Technical Memorandum for 2875 Veterans Road West EAS

CEQR Number 10DCP050R

ULURP Number N140162ZCR

February 11, 2014

PROJECT NO.: CPC-01

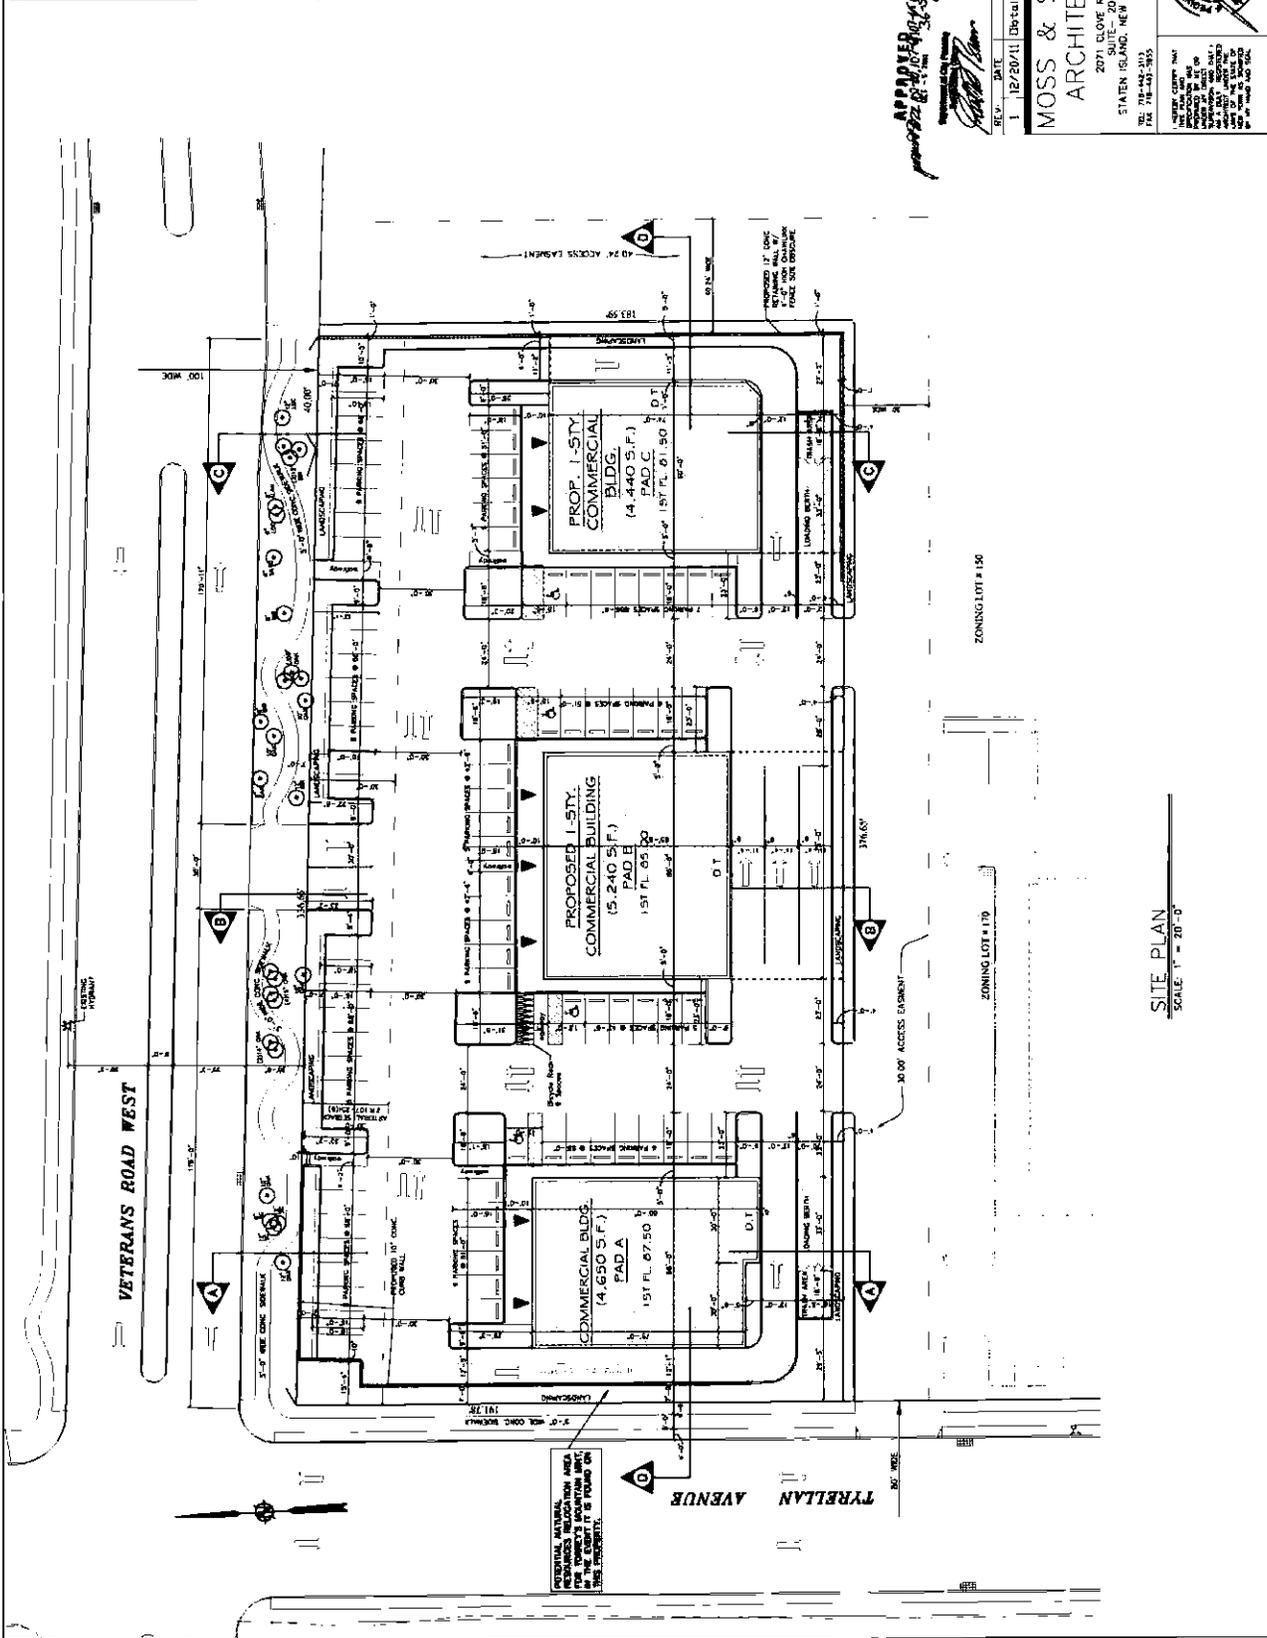
On April 4, 2012, the CPC approved three separate building pads, corresponding to three retail buildings, totaling 14,290 square feet in floor area, as itemized in Table No. 1 below. The CPC approved project was 52 gsf smaller than the project analyzed in this Technical Memorandum.

Pad A was approved for 4,650 square feet of floor area on a 60'-0" wide pad. Pad B was approved for 5,240 square feet of floor area on an 80'-0" wide pad. Pad C was approved for 4,440 square feet of floor area on a 60'-0" wide pad.

CPC-06

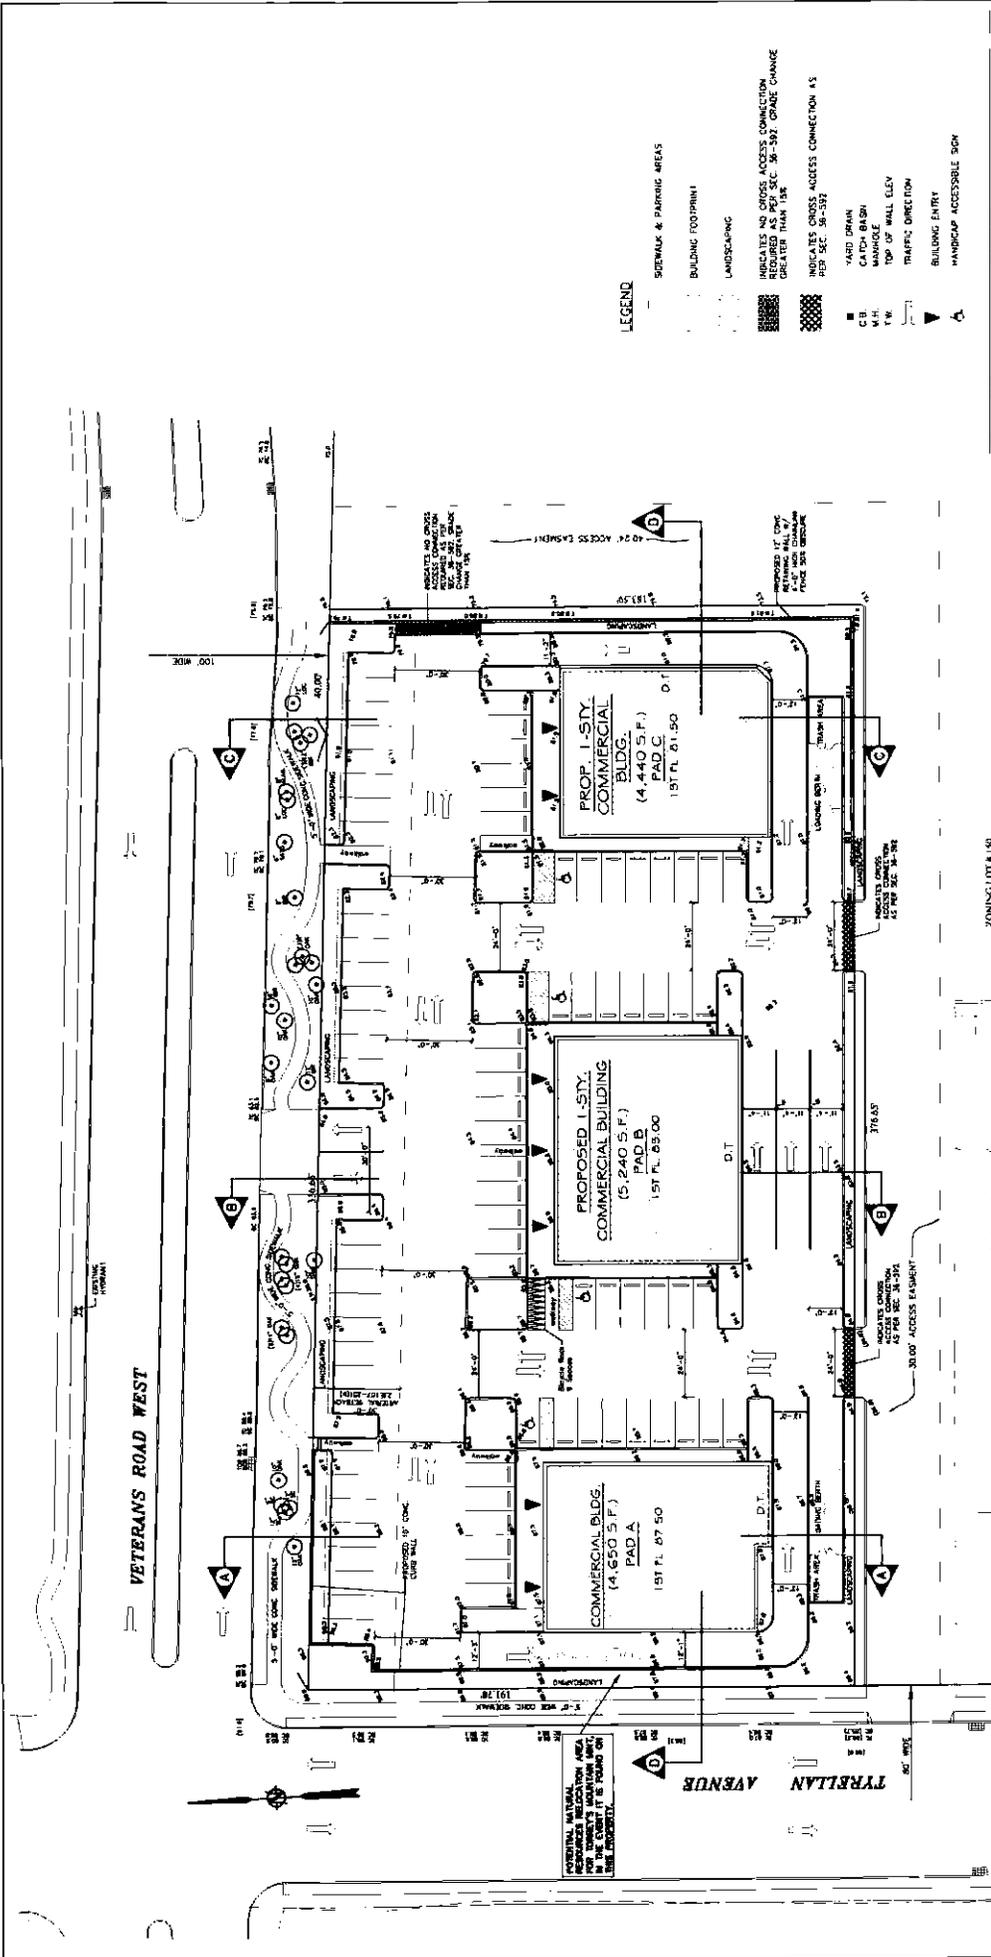
The CPC also approved two 24'-0" wide Cross Access Connections to a 30'-0" wide access easement bordering the southerly property line of the site.

The western Cross Access Connection is proposed to be moved 10'-3" west from its previously approved location (from 102'-2" from the western property line at Tyrellan Avenue to 91'-11" from the western property line). The eastern Cross Access Connection is proposed to be moved 14'-10" east from its previously approved location (from 252'-2" from the western property line at Tyrellan Avenue to 267'-0" from the western property line). No other changes to the projected development analyzed in the June 2, 2011 EAS are proposed in the 08/06/13 Final Design.

Figure 17-3:
Stationary Source Screen

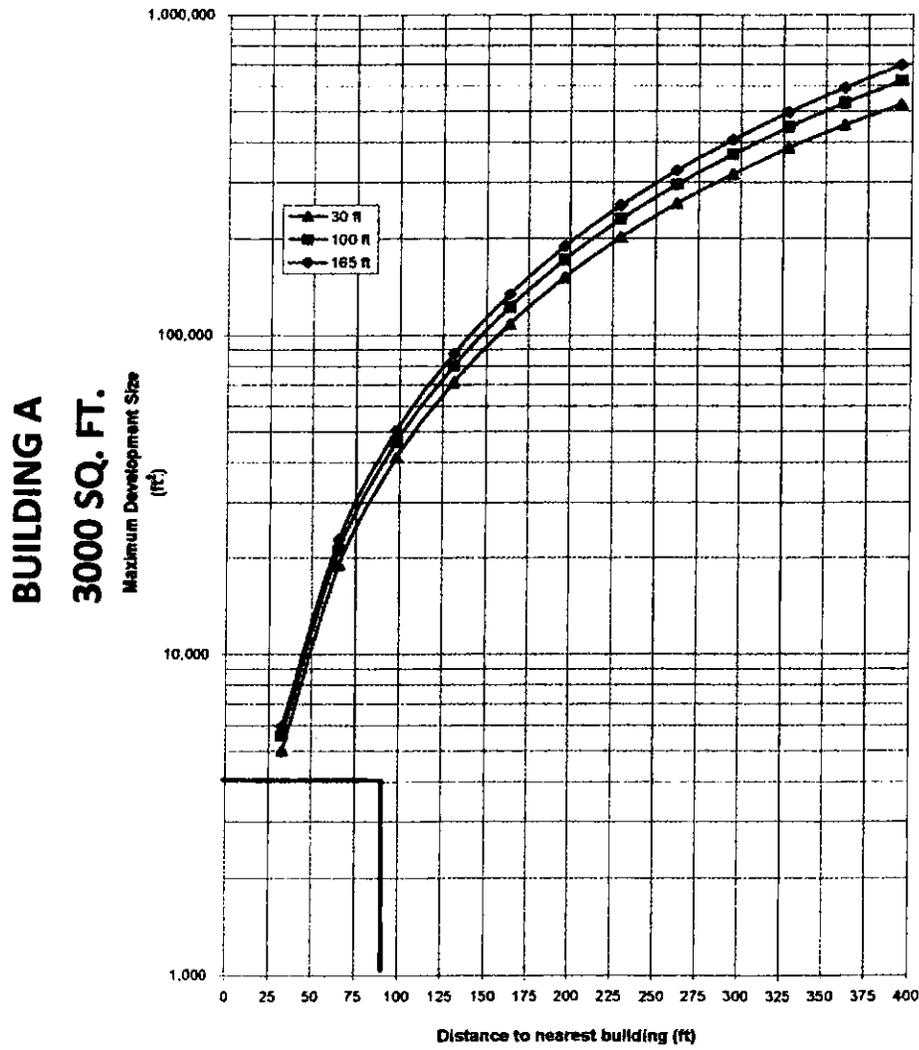
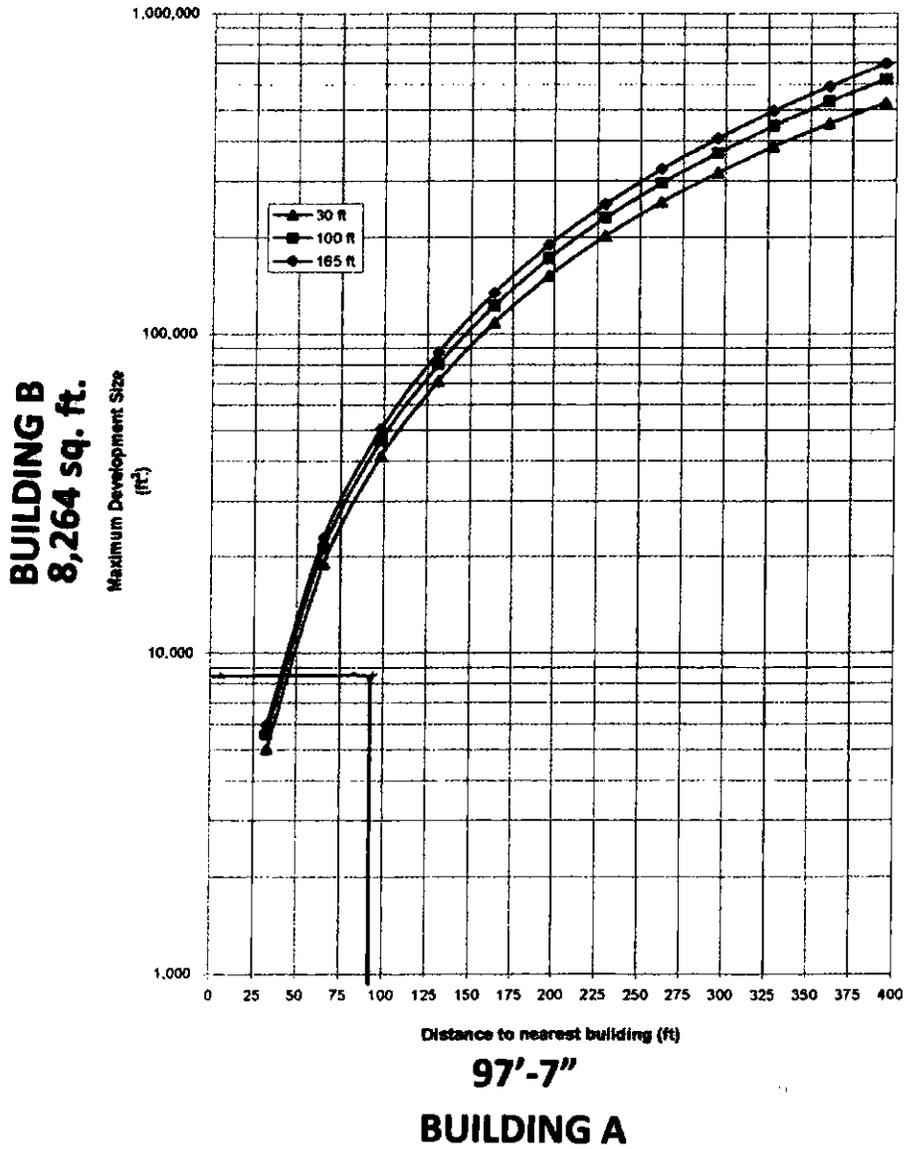
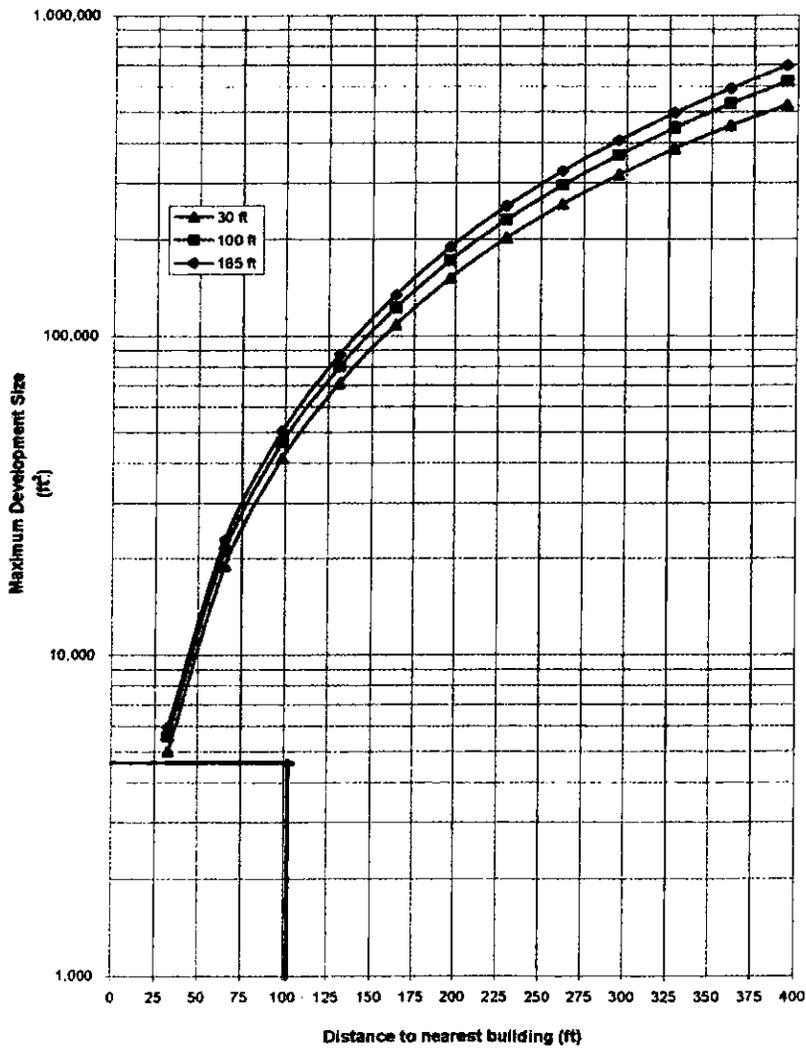
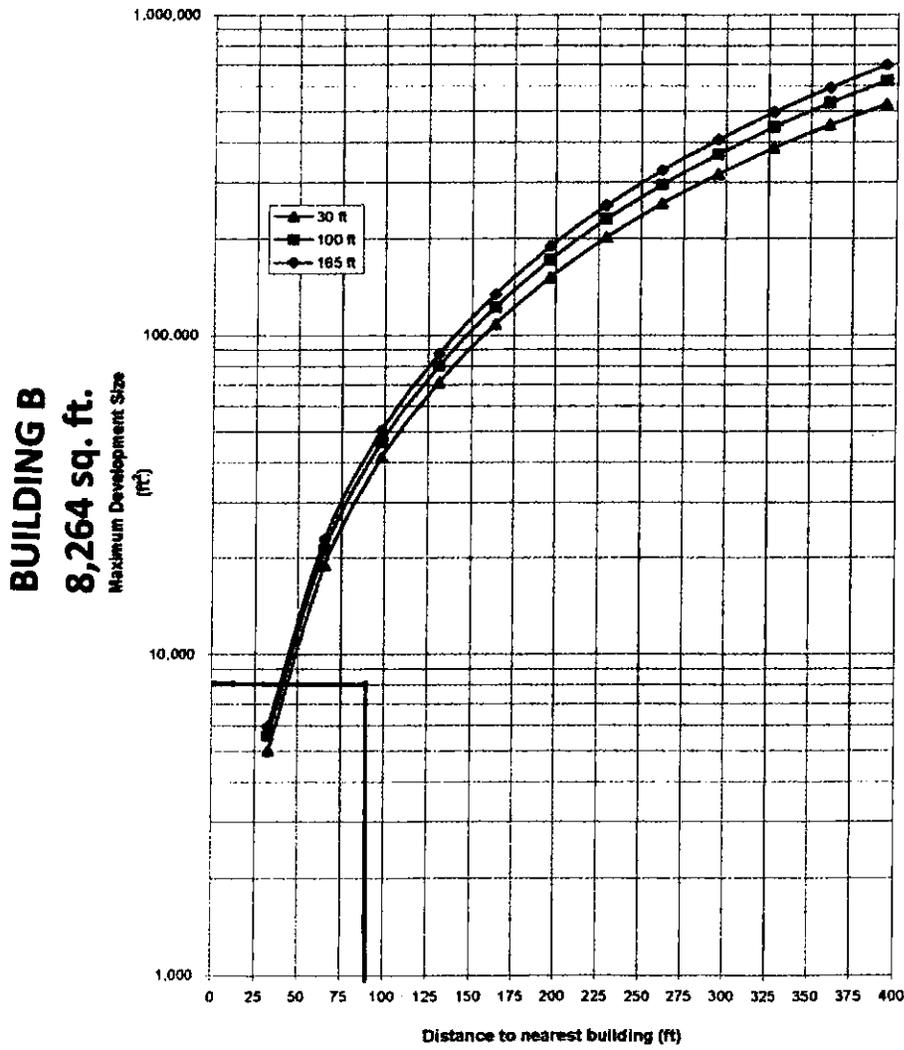
A new screening analysis was conducted using Figure 17-3 of the Air Quality chapter of the 2012 *CEQR Technical Manual* (see attached **Flue Location Site Plan** dated 02/04/14). The proposed buildings would range between 3,000 square feet and 8,264 square feet in size and the distances of the buildings' boiler flues from Tyrellan Avenue are provided below.

- The flue on the 3,000 square foot proposed Building A would be located 44'-3" from Tyrellan Avenue.
- The proposed 8,264 square foot Building B would have two separate boiler flues. The western flue on proposed Building B would be located 166'-8" from Tyrellan Avenue. The eastern flue on proposed Building B would be located 216'-8" from Tyrellan Avenue.
- The flue on the 4,987 proposed Building C would be located 345'-5" from Tyrellan Avenue.

On the basis of Figure 17-3 of the Air Quality chapter of the 2012 *CEQR Technical Manual*, the plotted point is below the applicable curve for all the proposed boiler flue locations relative to the adjacent building. A potential significant impact due to boiler stack emissions is unlikely and no further analysis is needed. Therefore, the conclusions of the Air Quality section of the June 2, 2011 EAS remain unchanged.
